Access Compliance Report

Public Rights-of-Way

(Pedestrian Signals)

Intersection ID: N/A	Main Street:	Cross Street: N/A	Location: N/A
ADA ID: E1FE5C45370B	Signal Type: One Push Button-Non APS	Overall Compliance: No	Severity Score: BTN 1: N/A BTN 2: N/A No BTN: N/A
Codes/Mitigation Info/Possible Solution		Field Measurements/Component Compliance

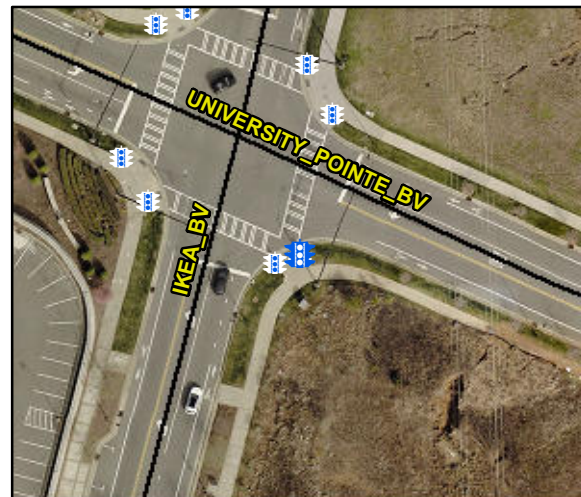
PROW/ADA: TMUTCD 4e.08, R404.2, R404.3, R406.2, R404.7.2

Possible Solutions: Replace Signal Push Button With APS Button on New Post. Remove & Relocate Sign.
